Project Name: Jax Car Wash

Description: Preliminary Site Plan approval and PB Approval

**RE: Jax Kar Wash- Preliminary Site Plan Review – 2<sup>nd</sup> Review**

**Preliminary Site Plan / Planned Business Review  
for  
White Lake Charter Township, Michigan**

DRAWING TITLE  
**TOPOGRAPHIC SURVEY**

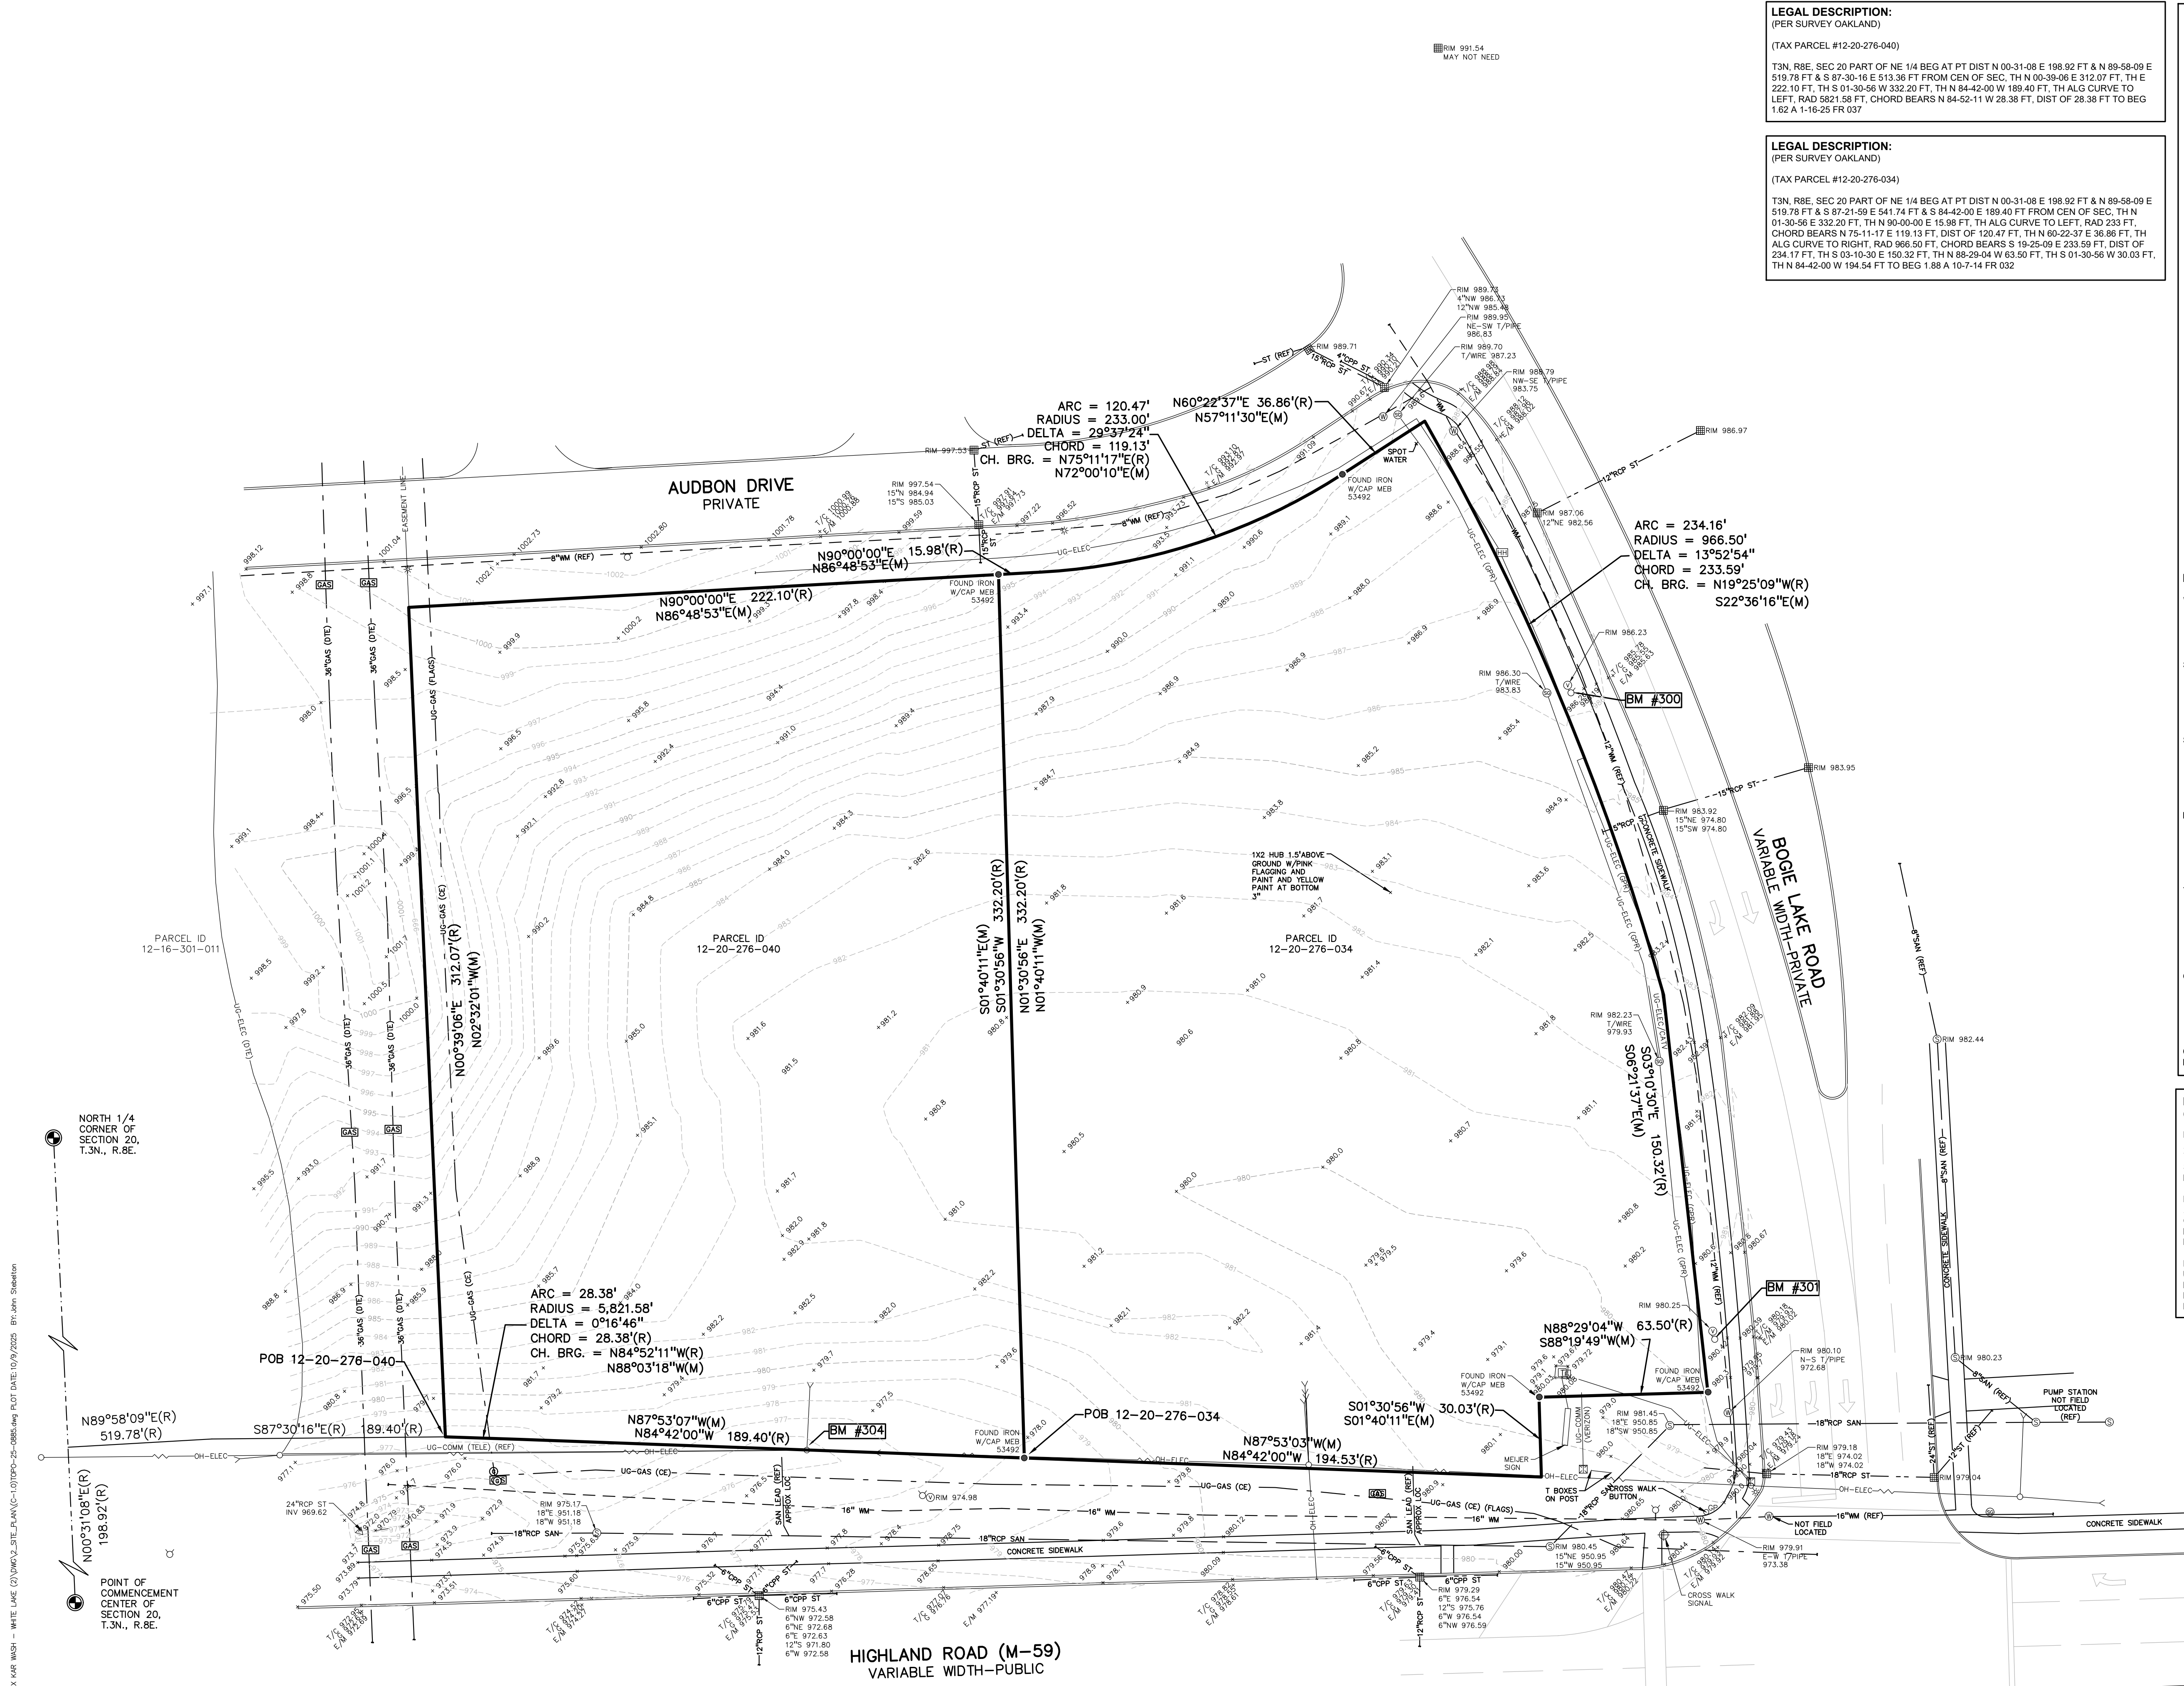
- b) *Verify BM elevations for BMs 300 and 301. The elevations for these two benchmarks are approximately 2' higher than the identical benchmarks shown on the previous Cosmo's Car Wash plan for this parcel. Comment partially addressed. Design engineer has stated that the benchmarks for the former Cosmo's Car Wash had incorrect descriptions. Please place a PS seal and signature on Sheet C-1.0 as certification that a PS has prepared and reviewed the topographic survey.*

**OVERALL  
SITE PLAN**

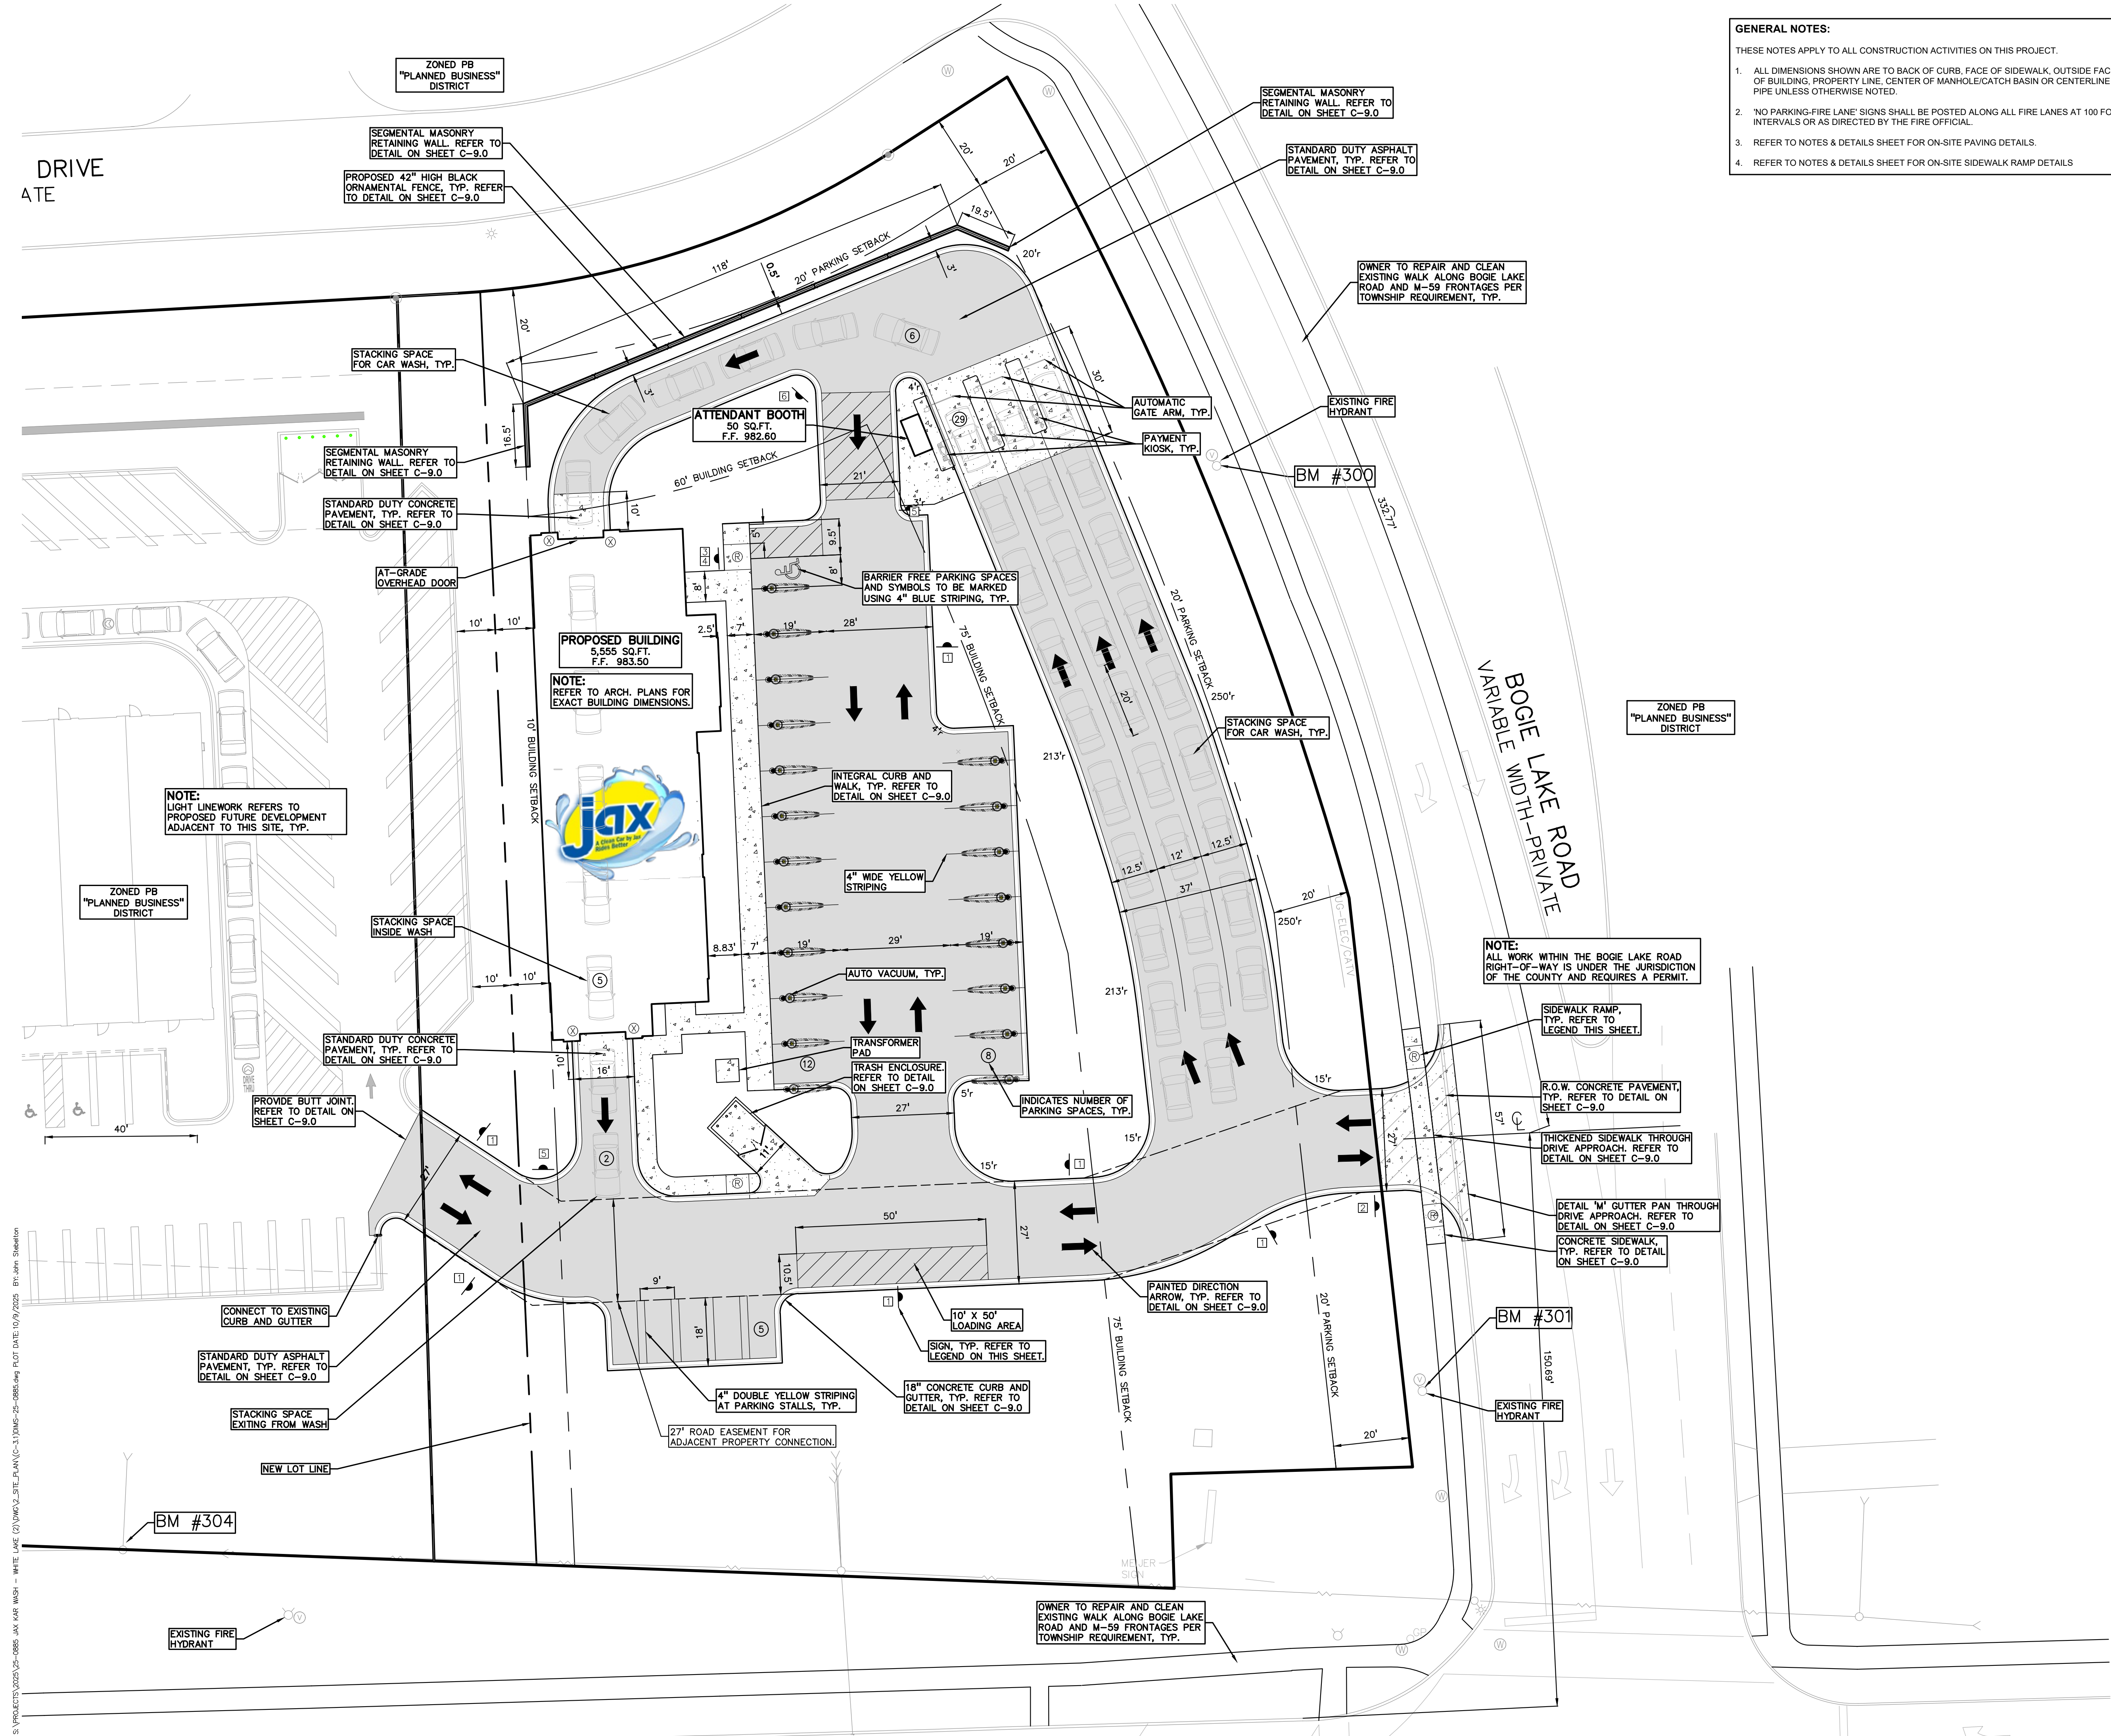
Sheet C-3.0 proposes a new western lot line. This proposal reduces the current lot size and allocates more land to the neighboring lot to the west. The site plan for the lot to the west does not reflect what was approved by the Planning Commission in January of 2025. This review will be conducted as if the lot modification is approved however a modified site plan may be required for the neighboring lot to the west.

***Item to be Addressed:*** Western lot line modification approval will be required for final site plan approval and may require a modified site plan for the development directly west of the site.

DRAWING TITLE  
**FIRE TRUCK  
MANEUVERING  
PLAN**

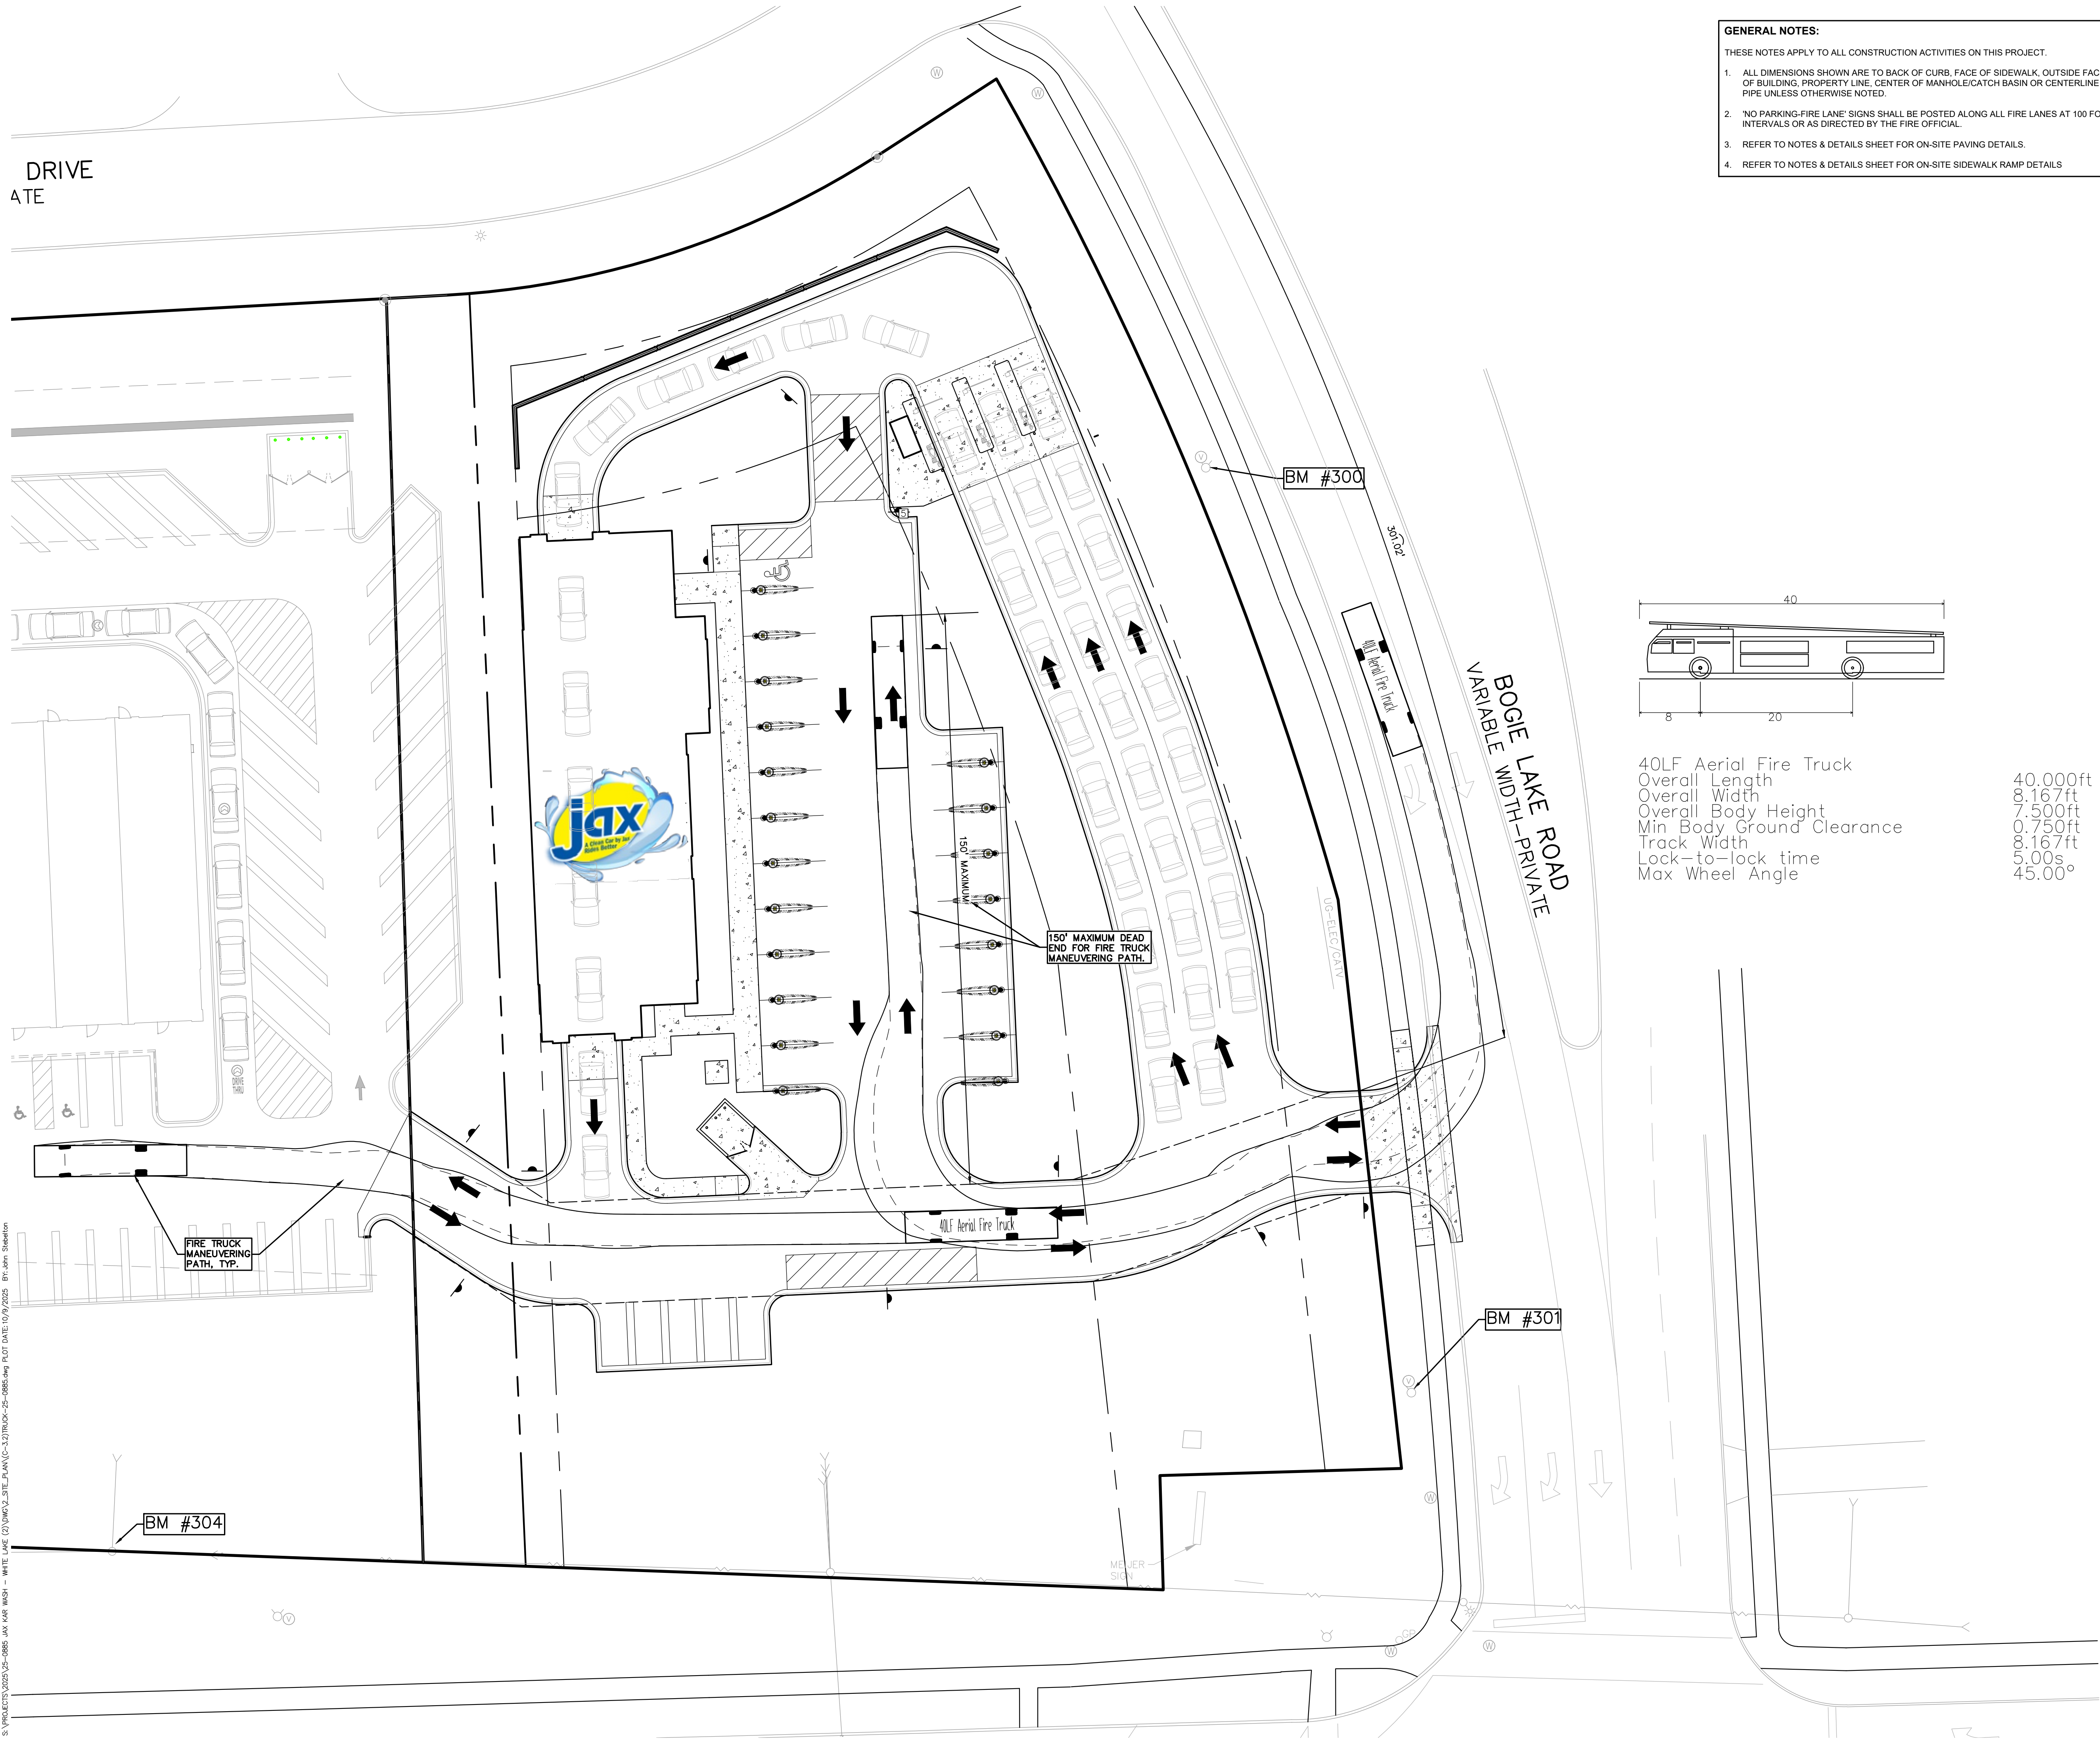
- g) *Provide fire truck turning radii plan that also demonstrates ingress, internal circulation, and egress of a standard 40' length fire truck on the site. Comment addressed. Fire truck turning radii plan has now been provided.*
